The Blowhole Viewing Platform, Port Campbell Coast

The Port Campbell Community Group Inc. is deeply concerned at the unsympathetic design and negative environmental impacts of the Blowhole viewing platform, again going ahead without community consultation.

New views at Loch Ard Gorge

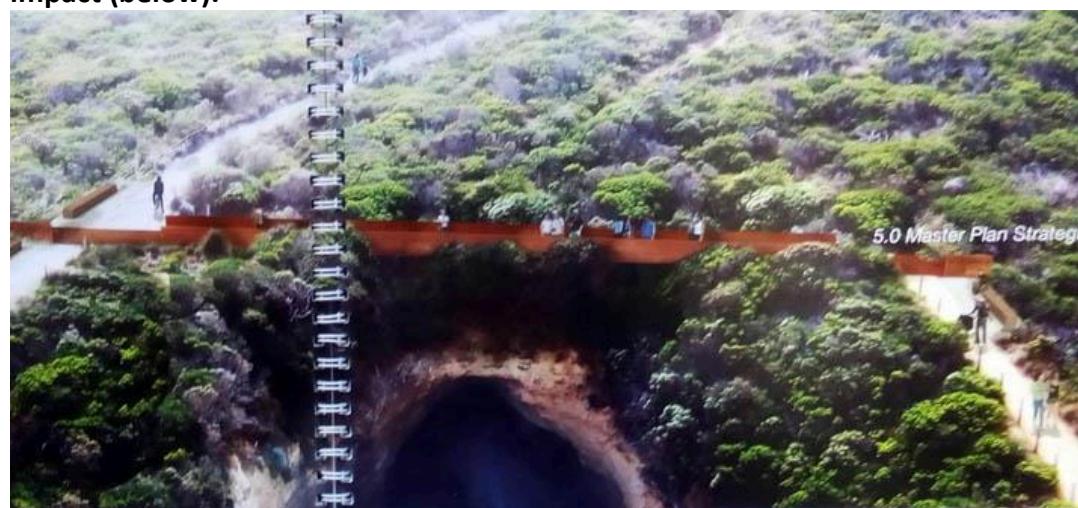
The enormous polycarbonate design, a black tube, is a blight on the natural landscape and will become a wind tunnel in this extreme environment, and it could collapse the cavity beneath.

The design (above) is far different to that shown in the Shipwreck Coast Master Plan (SCMP) which was shown to the community and which had low visual and environmental impact (below).

Photo PCCG Inc. Blowhole sign, c 2000

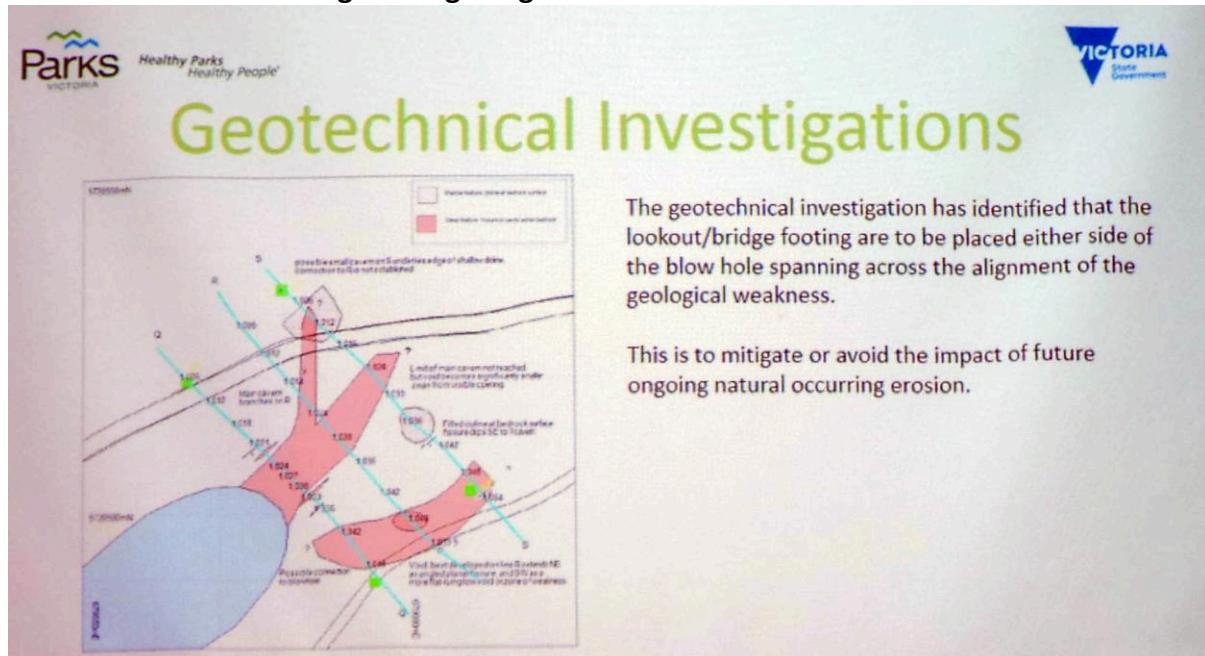
A Parks Victoria information session 31-8-2017 at Port Campbell showed a geotechnical plan (below) which coincides with the SCMP design where the bridging design would go straight across the Blowhole and little or no requirement for masses of concrete over a cavern – the area of recognised “geological weakness”.

The Community has not been shown how the masses of concrete and new design considers geotechnical issues and the fragile limestone. Photos: 19-12-2024

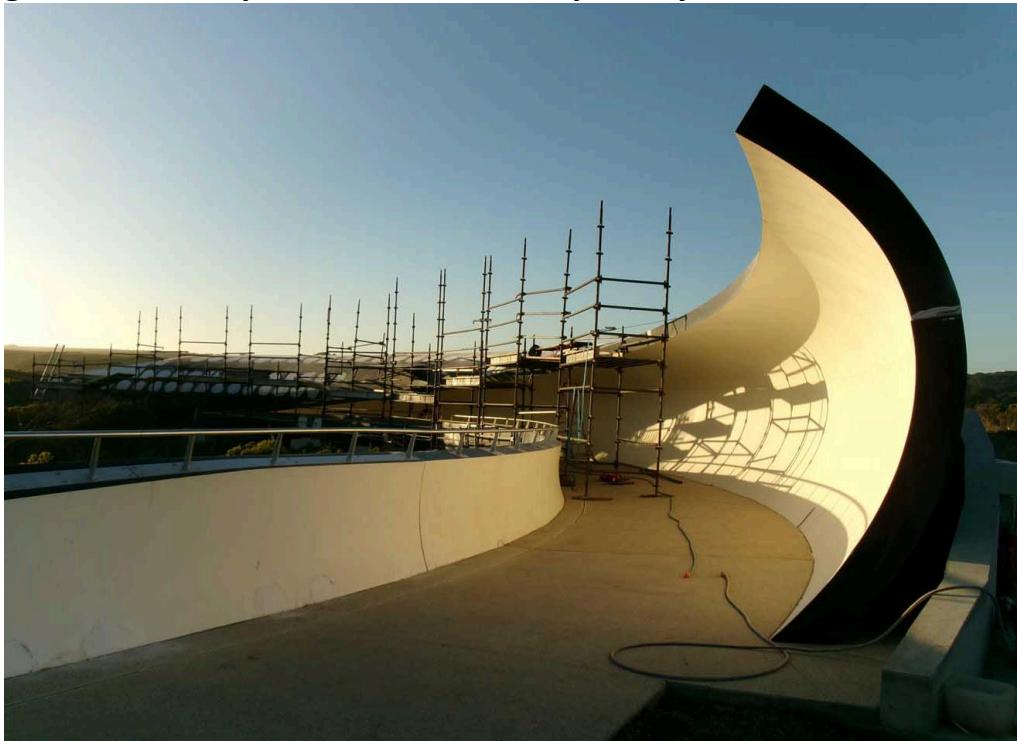
At The Blowhole site however, further work is considered mandatory to locate the hidden and apparently large cavity. Further geophysical work could be carried out in an effort to expand our knowledge of the apparent resistivity 'high' shown on the model in Appendix 4 but backup drilling would still be required to prove the location and nature of the cavity.

If the hidden cavity has a roof level as high as is alleged (15+ m), there is the possibility that the mass of the drilling rig may produce collapse of the structure similar to that which has occurred in the geologic past with The Blowhole. While this possibility is considered to be remote, it cannot be discounted.

What work has been done to consider whether the extensive concrete foundations could collapse the cavern underneath?

- Drilling a further bore (or bores) on the north side of the road to locate the tunnel leading from The Blowhole and then to follow this line of drilling until the main cavity is reached.
- Attempt, by drilling, to delineate the perimeter of the cavity. This drilling investigation would need to be supplemented by further geophysical testing to expand the area previously covered. This may include geophysical techniques other than conductivity surveying.
